LAURIE DOWNS, ET AL
Request for Commission Investigation Into
the New Central Maine Power Company
Transmission Line Proposal for Eliot, Kittery
And York

STAFF REPORT

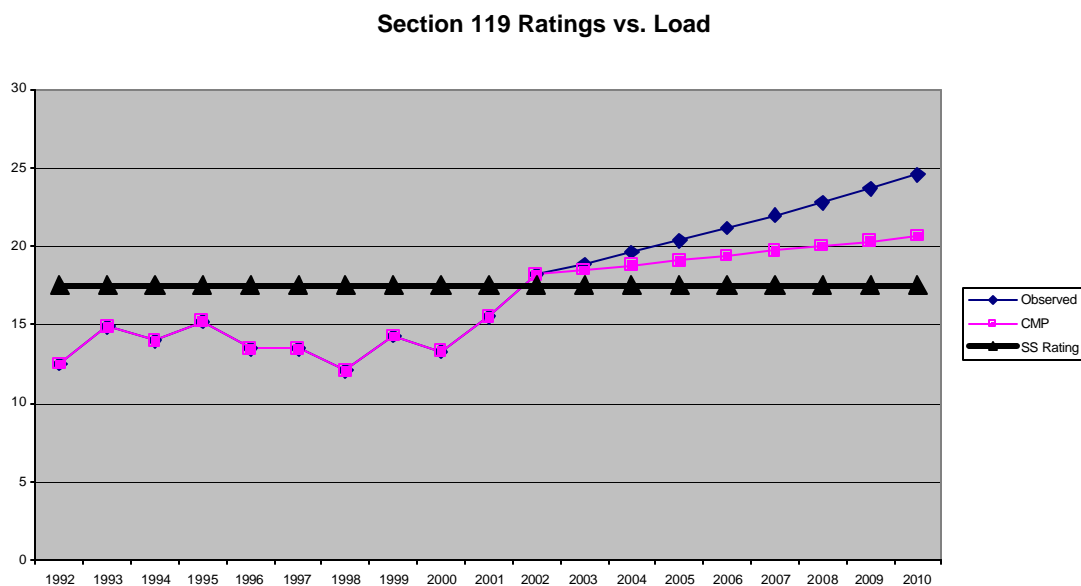
Based on actual and its projected loadings on the existing line sections and substations, the most critical need identified in the Duke Study is to reduce the loadings along section 119, which is the line between the Quaker Hill and Ogunquit

substations. As can be seen from the chart below, section 119 exceeded its ratings during the summer of 2002. The chart also shows future loadings on section 119 at the two load growth scenarios described above. The line labeled “CMP” shows the expected loadings on the line using 1.6% per year growth. The line labeled “Observed,” reflects an extension of recent actual.

Ogunquit Substation Ratings vs. Load

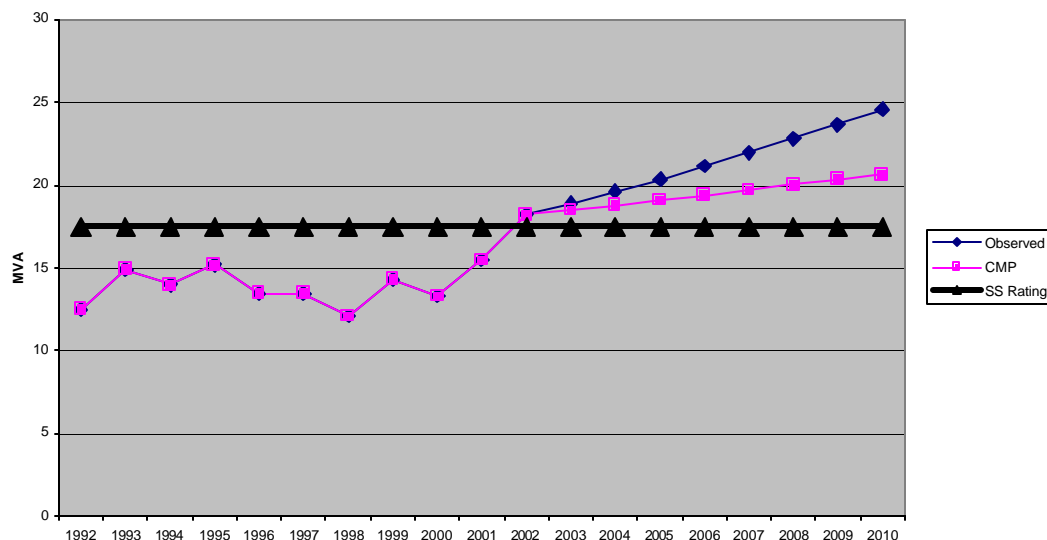
In addition, the Ogunquit substation (where section 119 terminates) also exceeded its rating in the summer of 2002. The following chart displays summer peak loadings on the Ogunquit substation for the last ten years and using the two load growth scenarios described above.

York Beach Substation ratings vs. Load

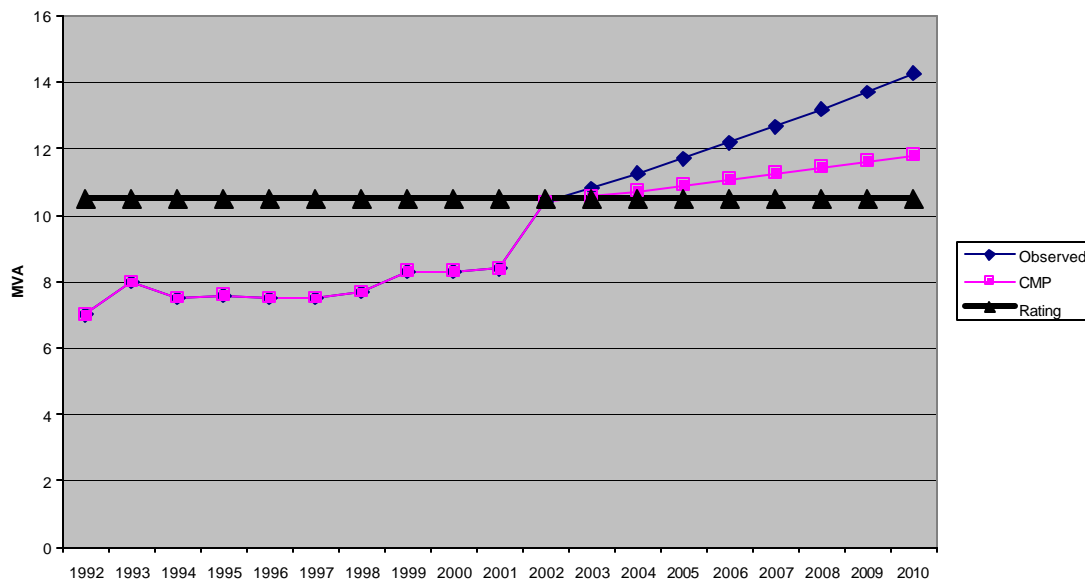
The York Harbor substation and transmission line section 139 have not yet exceeded their rated levels, but, depending on the growth rate assumed, would do so within the next 2-to-7 years. The York Beach substation, however, experienced a steep increase in demand between the summers of 2001 and 2002, resulting in loadings that nearly matched the station's rating. This increase, nearly 2 MVA, represented a more than 20% growth in the peak demand on this substation in just one year. The chart below displays this, and shows expected loads on the substation under the two load growth scenarios.
